Well Name: DAVIDSON GAS COM F	Well Location: T28N / R10W / SEC 28 / SENW / 36.636215 / -107.904221	County or Parish/State: SAN JUAN / NM
Well Number: 1E	Type of Well: CONVENTIONAL GAS WELL	Allottee or Tribe Name:
Lease Number: NMSF077383A	Unit or CA Name: DAVIDSON GAS COM F	Unit or CA Number: NMNM73558
US Well Number: 3004524113	Well Status: Producing Gas Well	Operator: HILCORP ENERGY COMPANY

Notice of Intent

Sundry ID: 2664073

Well: Davidson Gas Com F 1E

Schematic - Proposed

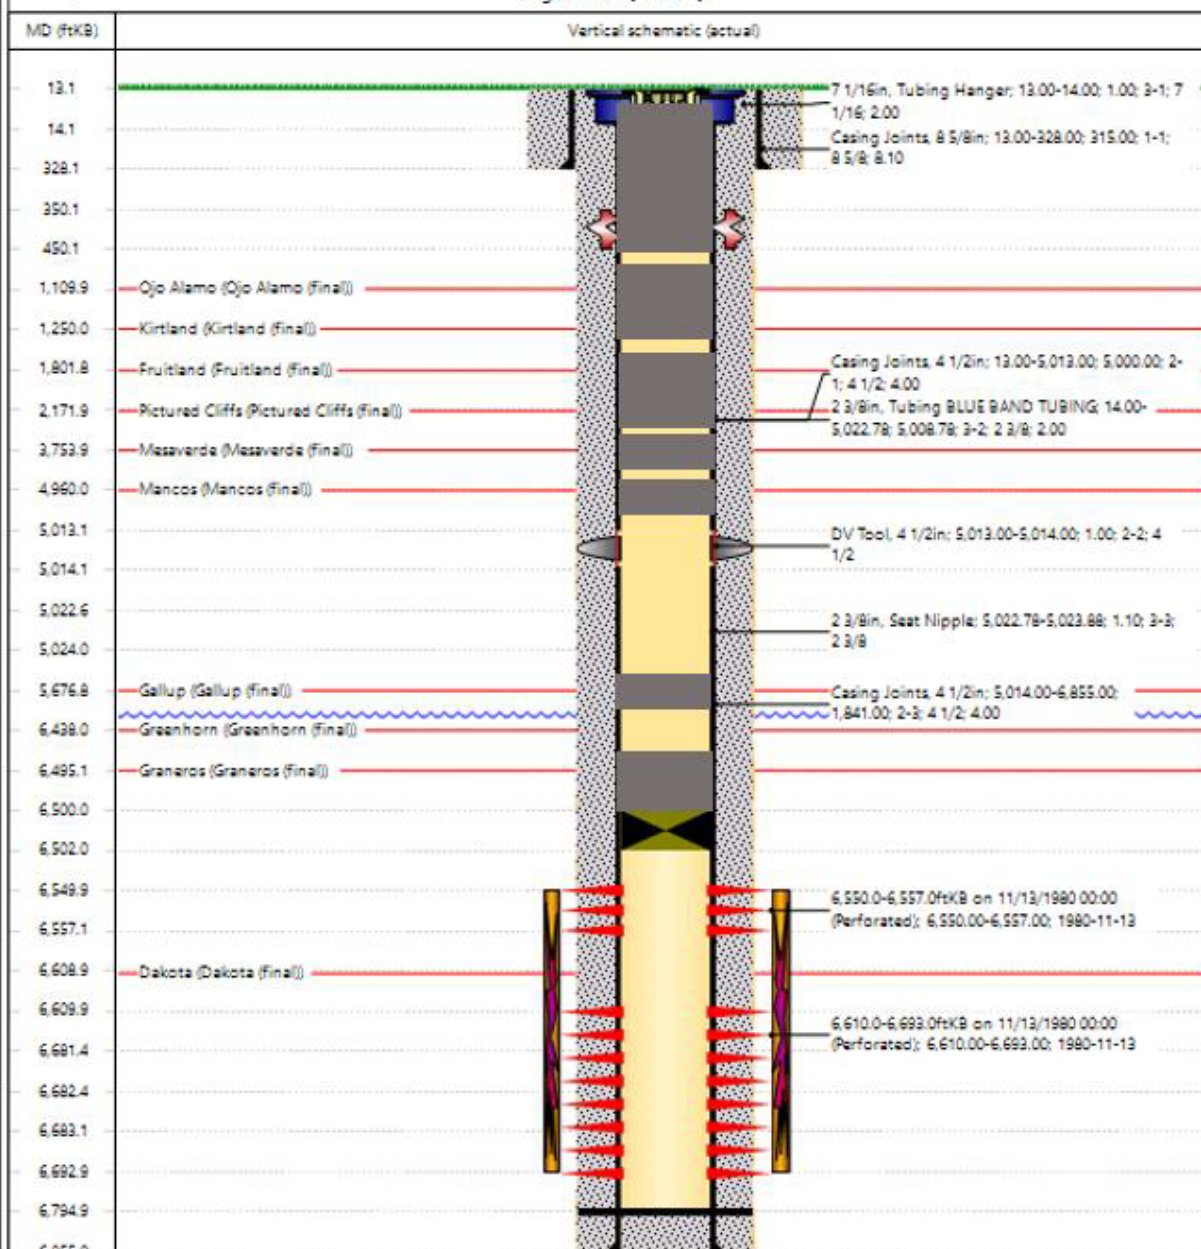
1. Plugging operations authorized are subject to the attached "General Requirements for Permanent Abandonment of Wells on Federal and Indian Lease."
2. The following modifications to your plugging program are to be made:
 - a) Adjust Plug #3 (Mancos) to cover BLM formation top pick at 4810'.
 - b) Add a plug to cover the Chacra formation top at 2725'.
3. Farmington Office is to be notified at least 24 hours before the plugging operations commence at (505) 564-7750.

- BLM picks for the Fruitland and Mancos formation tops vary from Operator submission.

- Adjust Plug #3 (Mancos) to cover BLM formation top pick at 4810'.

- Add a plug to cover the Chacra formation top at 2725'.
